22 December 2023

**RR-2022-31 – PLANNING PROPOSAL 2021-3409 AT NO'S.361-365 NORTH ROCKS ROAD, NORTH ROCKS**

Figure 1: North Rocks Road Boundary Interface

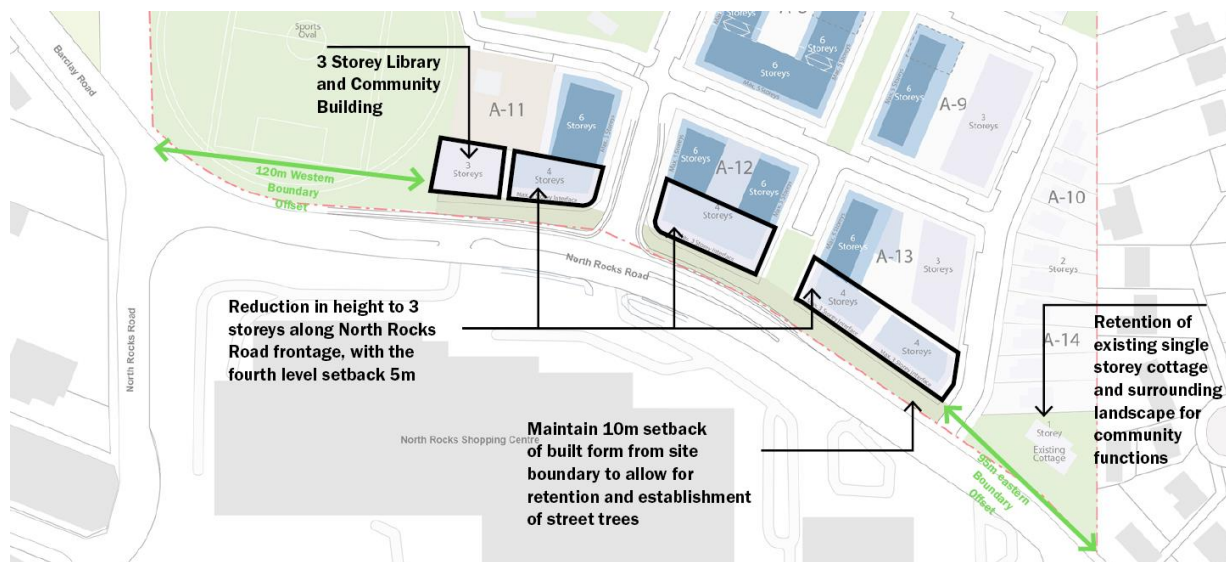
*The scale of the proposed development is to be compatible with the interface along North Rocks Road up to a maximum of three storeys.*

The interface to North Rocks Road can be refined to reduce the heights and maintain a maximum 3 storey interface to North Rocks Road. Although it is noted there is no clear rationale for this height limitation and the shopping centre site opposite has a current building height of 12m.

A setback fourth level can be included (to be consistent with the height control opposite) but with a generous 5m upper floor setback to allow for a landscaped edge and scale transition into the site, supporting the landscape character and urban design outcomes of the master plan.

- 1) A 10m southern boundary setback is provided along North Rocks Road to allow for the retention and establishment street trees along this edge to complement the landscape character of the North Rocks area.

Figure 2: Western and Eastern Interface Strategies

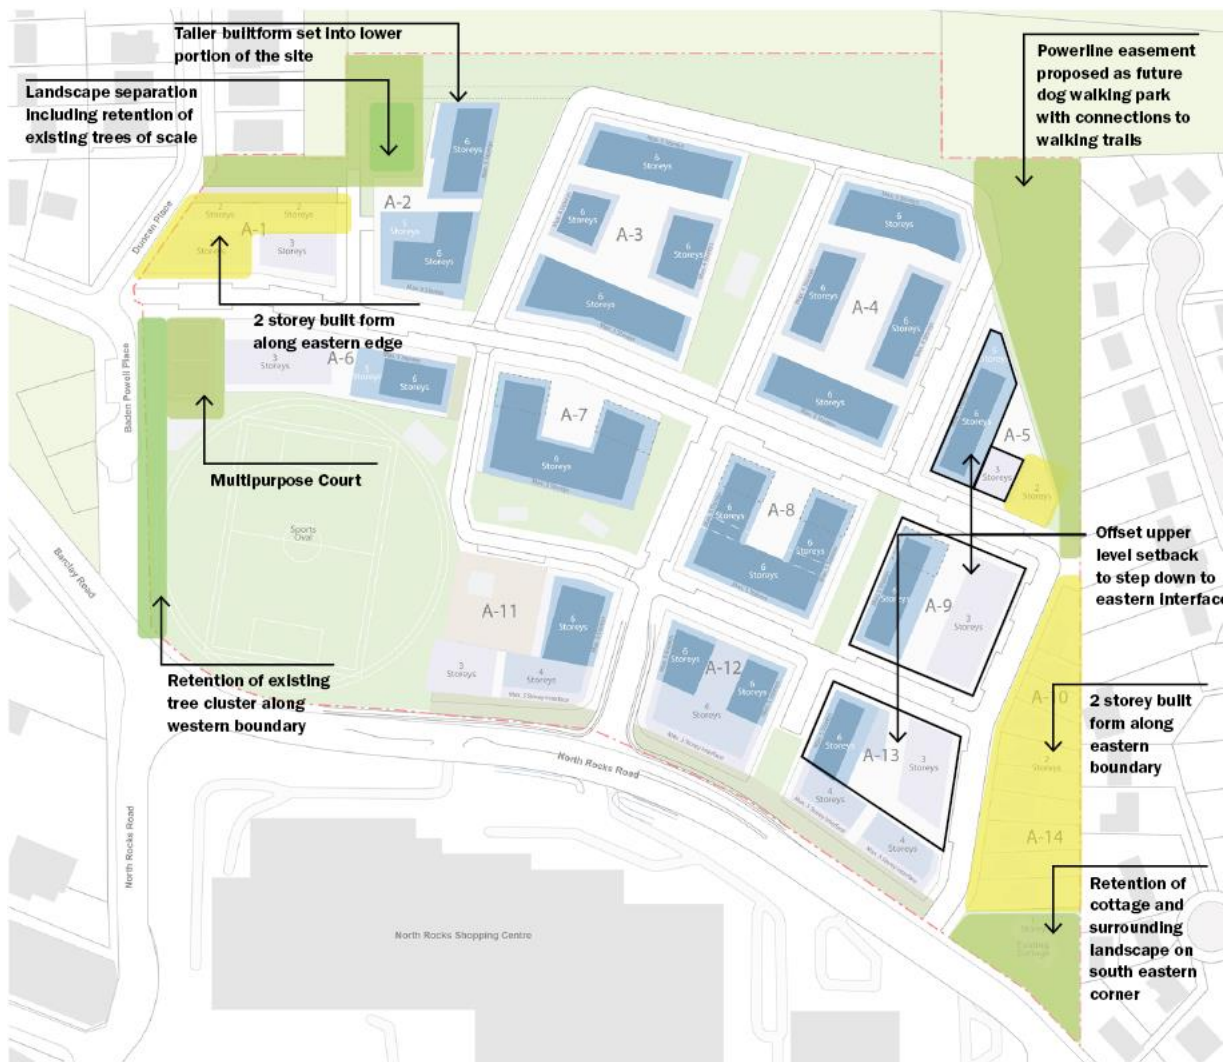
*The scale of the proposed development along the eastern and western boundaries is to be no more than a maximum of two storeys.*

In response to the Panel recommendation, further refinement along these boundaries can be undertaken to ensure a 2-storey interface in these locations is maintained with a stepping down of the built form towards the eastern and western boundaries.

Upper-level setbacks can be increased and offset from these edges to further transition height towards the eastern and western boundaries of the site.

Figure 6: Diagram indicating further amendments based on site response and approach.

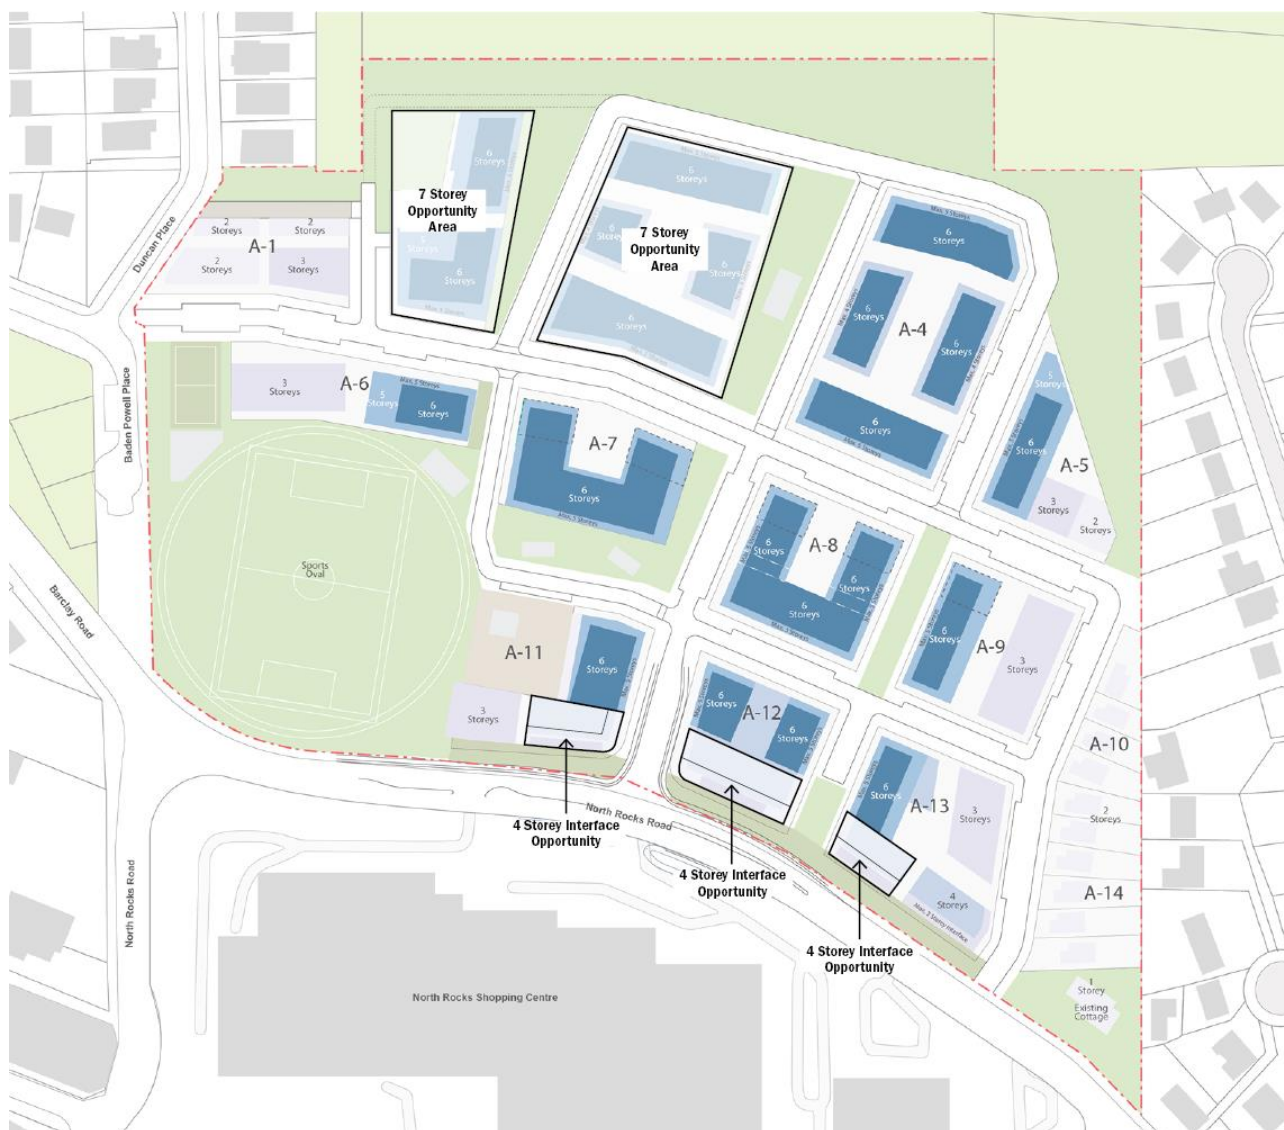
*Notwithstanding the lower heights at the interface with the existing neighbourhoods, the heights of buildings across the site are to be stepped down the site to relate to the sloping topography, with a maximum of five storeys, with potential for an additional one storey at the top-level setback, to minimise visual bulk and amenity impacts, and stepping down to two to three storeys.*

- 2) Should the panel disagree and seek to implement overall reduction in height as per the Panel's suggested recommendation, then it is respectfully requested the masterplan retain the potential to achieve one (1) additional storey but in limited parts of the site, only where it will have negligible visual or other environmental impacts, such as overshadowing, whilst supporting and not compromising the suggested urban design rationale of the Panel.

That is, a recessed additional one (1) storey in height can be accommodated but within limited parts of the site only being:

- the far north-western corner (from 6 up to a potential 7th storey), where the topography falls away and can accommodate an additional level without any adverse impact, and
- along the central part of the North Rocks Road frontage (from 3 up to a potential 4th storey), consistent with the historic 12m height control applying to the land opposite the site on North Rocks Road.

- a) 7 storey buildings within limited parts of the site (north-western corner as shown outlined).
- b) Additional design criterion to be applied to any proposed height above 5 storeys including any 7 storey elements, including:

- d) Maintain 4 storey built form along North Rocks Road confined to the centre of the site (as shown outlined) with generous landscaped offsets from the eastern and western site boundaries, with provision for a setback fifth storey element, held to the same additional criterion as above.
